CATAWBA NUCLEAR STATION, UNIT 1

AMENDMENT TO FACILITY OPERATING LICENSE

Amendment No. 52  
License No. NPF-35

Amendment No. 45  
License No. NPF-52

FIGURE 4.7-1  
SAMPLE PLAN 2) FOR SNUBBER FUNCTIONAL TEST

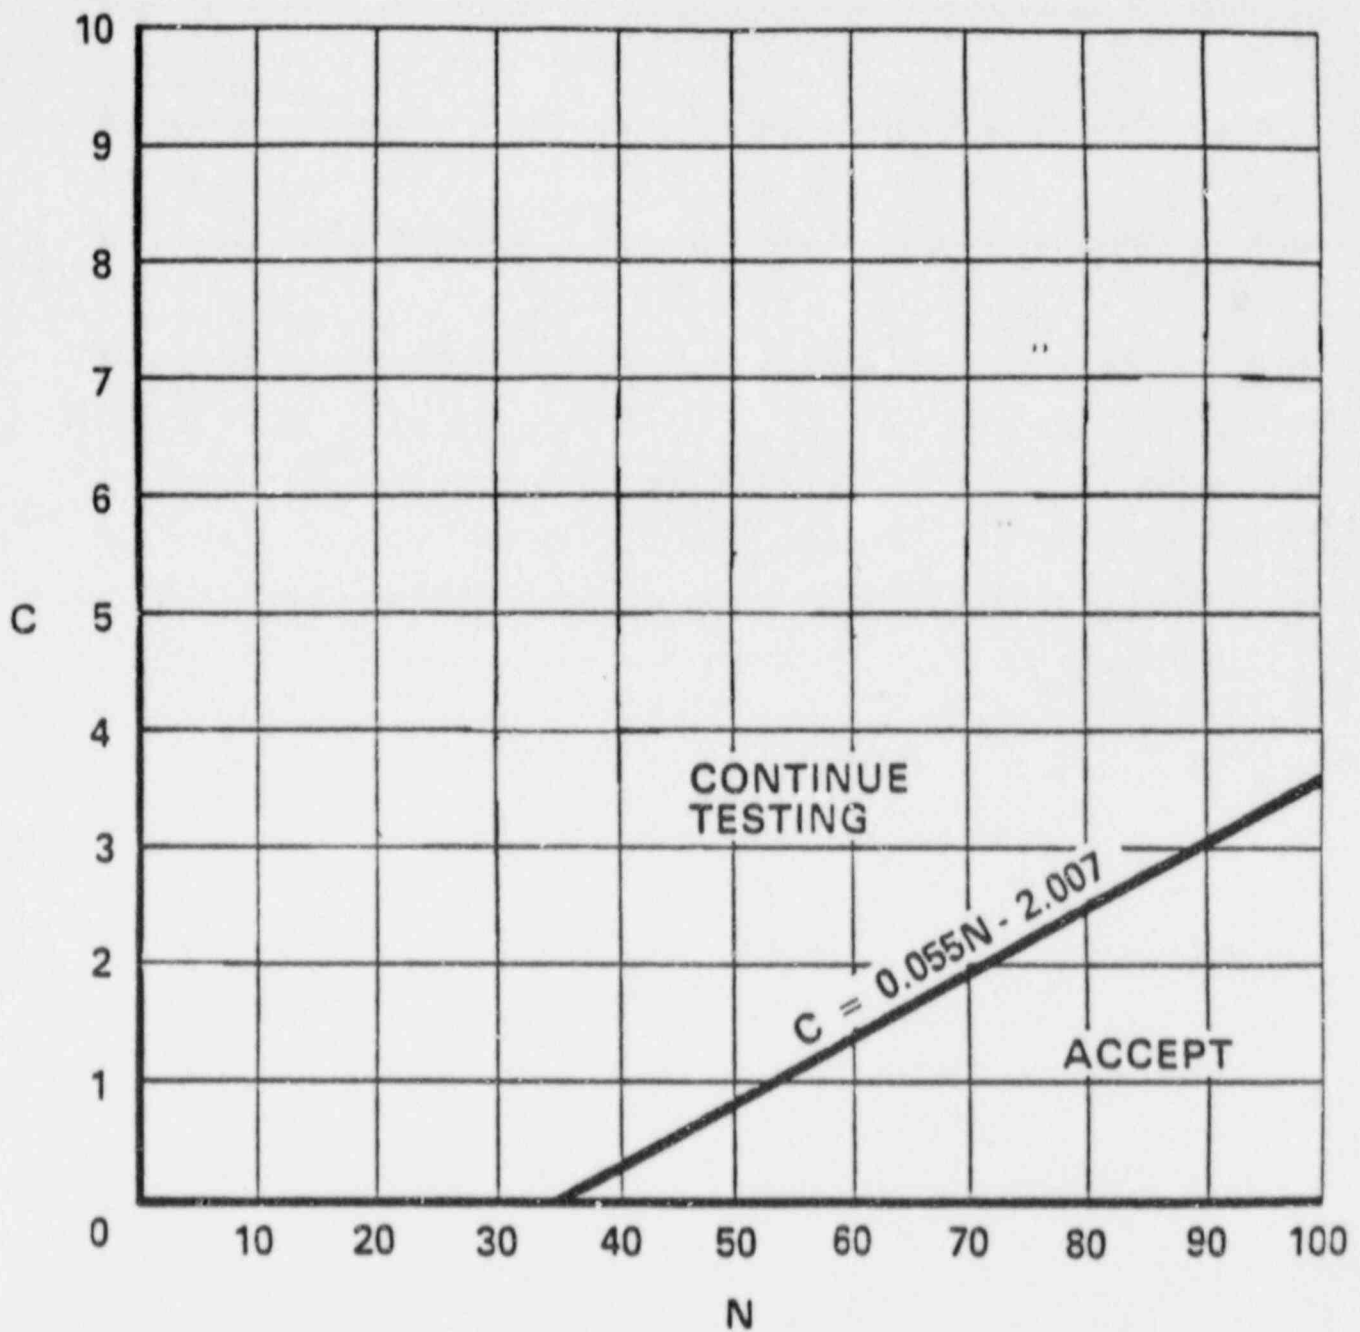
- 2) A representative sample of all snubbers shall be functionally tested in accordance with Figure 4.7-1. "C" is the total number of snubbers of a type found not meeting the acceptance requirements of Specification 4.7.8f. The cumulative number of snubbers tested is denoted by "N". At the end of each day's testing, the new values of "N" and "C" (previous day's total plus current day's increments) shall be plotted on Figure 4.7-1. If at any time the point plotted falls in the "Accept" region, testing of snubbers of that type may be terminated. When the point plotted lies in the "Continue Testing" region, additional snubbers of that type shall be tested until the point falls in the "Accept" region or all the snubbers of that type have been tested; or

1. Functionally test 10% of a type of snubber with an additional 10% tested for each functional testing failure, or
2. Functionally test a sample size and determine sample acceptance using Figure 4.7-1, or
3. Functionally test a representative sample size and determine sample acceptance or rejection using the stated equation.

Figure 4.7-1 was developed using "Wald's Sequential Probability Ratio Plan" as described in "Quality Control and Industrial Statistics" by Acheson J. Duncan.
